## 2. 11 Mall Road - Game On & Loretta's Last Call

## **PLANNING BOARD AGENDA FOR JANUARY 13, 2026 - 7:00 PM**

1. **Salem NIM, LLC Site Plan** – Public Hearing for change of use for 19,960 sq. ft. restaurant and entertainment use with conditional use permit for reduced parking and additional signage at 11 Mall Road, Map 107, Lot 11154. Continued from 12/9/2025.

# LYONS GROUP RESTAURANT AT THE MALL AT ROCKINGHAM PARK PLANNING BOARD SUBMISSION

# COLORED EXTERIOR ELEVATIONS

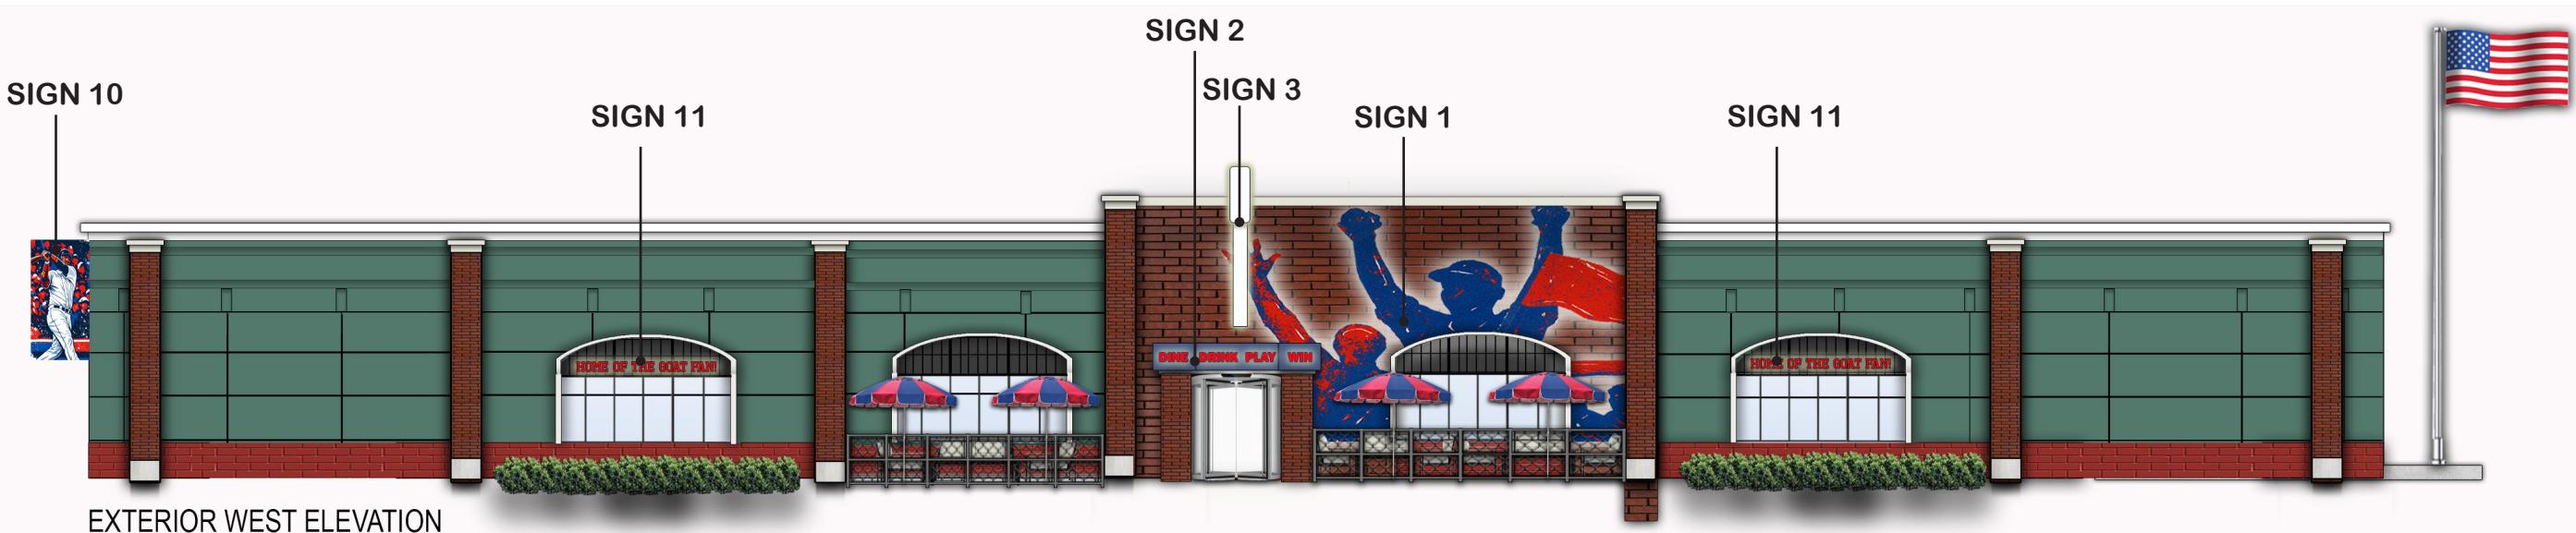
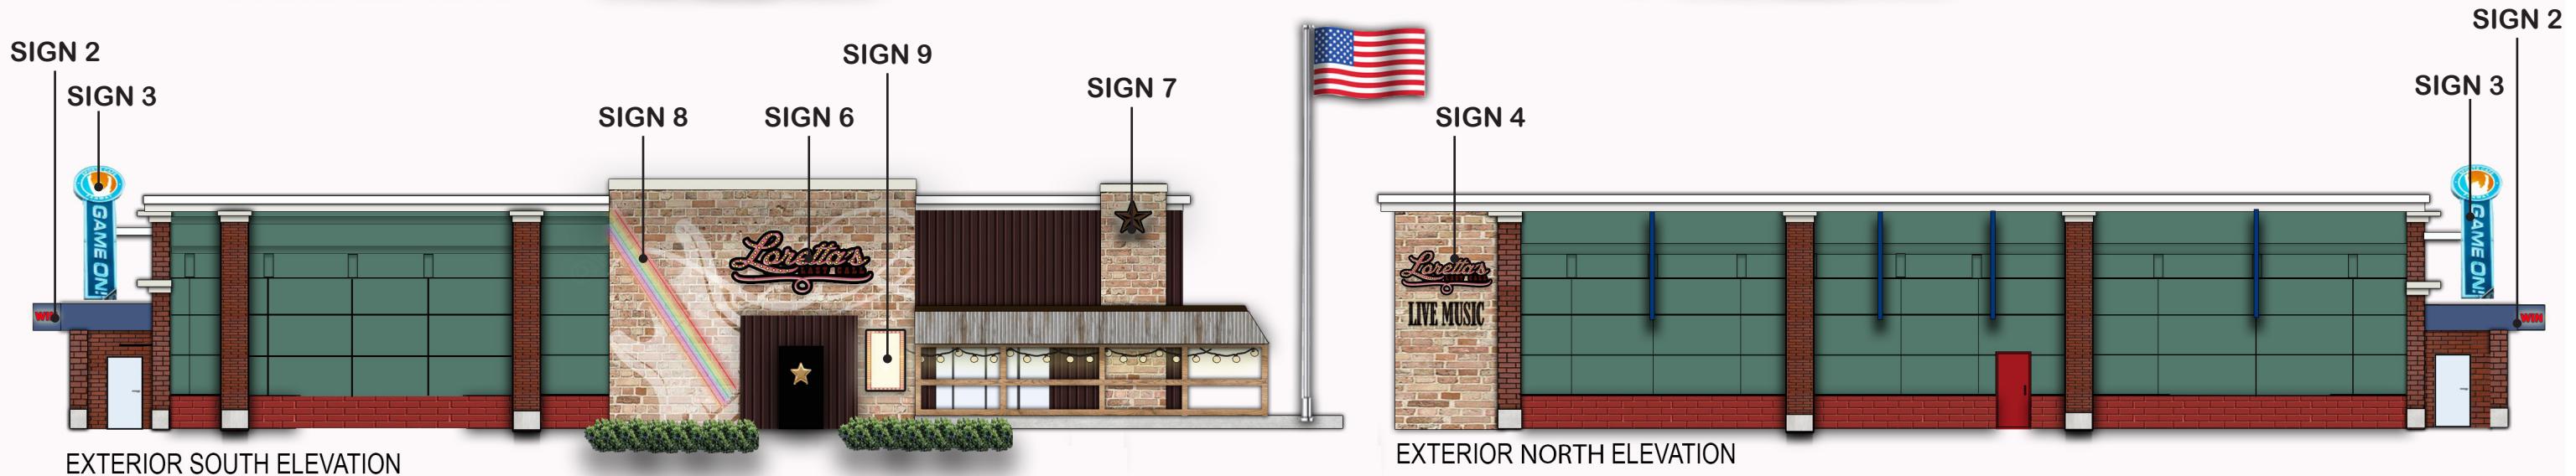
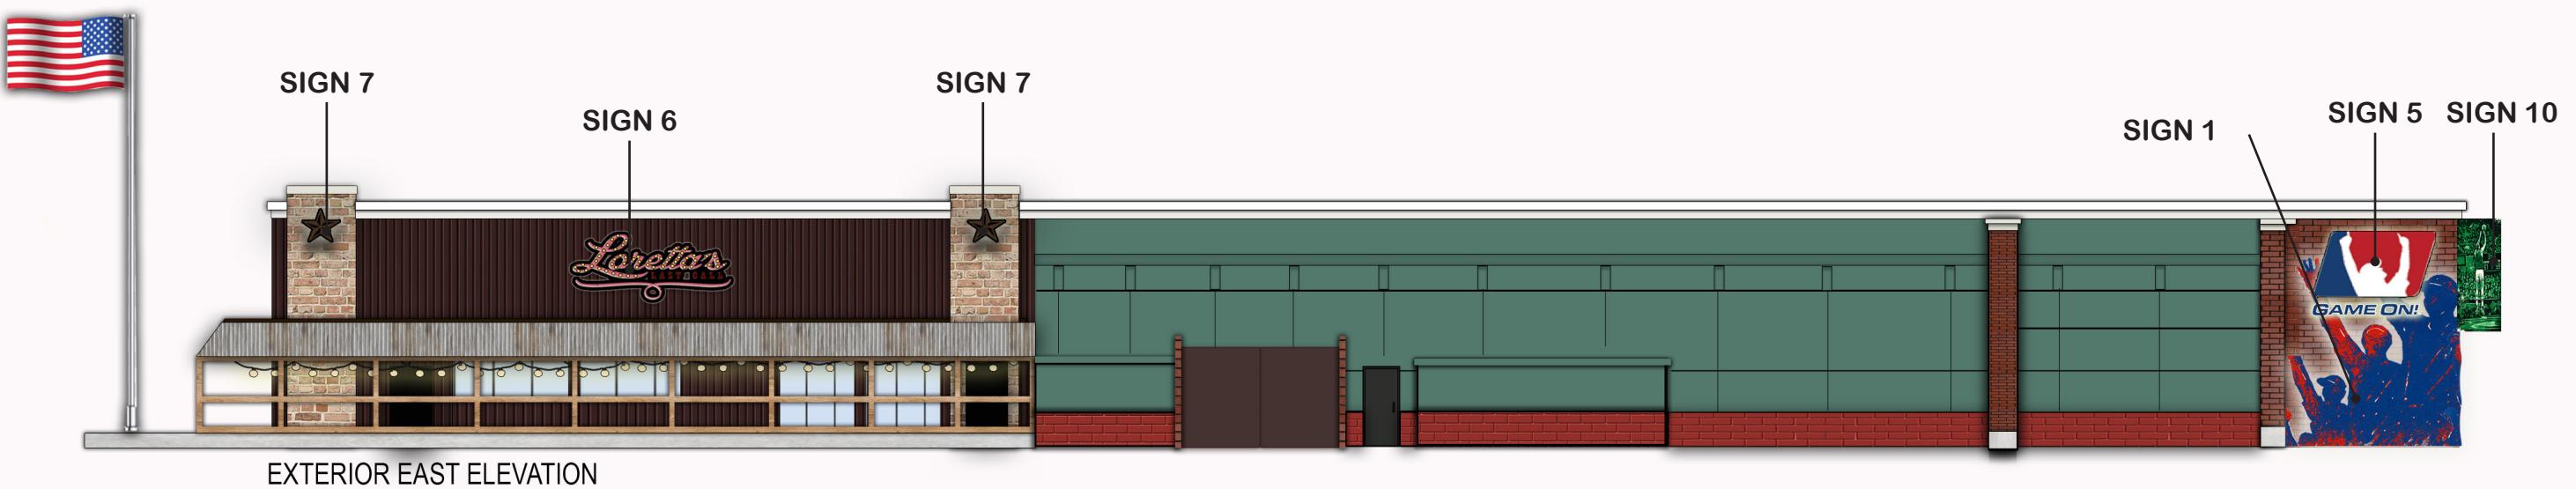
- Elevations:
  - Add legend – materials and color

**COMMENT RESPONSE:** Additional page has been added to the plans with the legend.
  - See [Design Guidelines](#) for Façade Design – pages 30-33
    - “For retail structures, any facade that faces a public or private street should have display windows, entry areas, or other transparent features along 40% or more of its horizontal length... Facades should not extend for more than 50 horizontal feet in length without incorporating architectural features, such as pilasters, windows, cornices, porches, corners, or offsets.”

fence; adding new brick for equipment storage and dumpster enclosure. Proposed modifications are attractive and welcomed improvements however building has blank walls on large portions of western, northern and eastern facades and eliminated transparency on western facade. Elevations should still be revised to better comply with Site Plan Regulations and Design Guidelines (see excerpts attached) – specifically to reduce blank walls, increase transparency, vary roofline; dumpster enclosure should be revised to match building.”

- **COMMENT RESPONSE:** This concern was addressed by adding the large window on either side of the entrance as well as two additional large windows beyond those two windows that are decorative.

**COMMENT RESPONSE:** This concern was addressed by adding the large window on either side of the entrance as well as two additional large windows beyond those two windows that are decorative. In addition, we have added banners on the North side of the building as well as an additional pilaster on the east face behind the equipment enclosure.
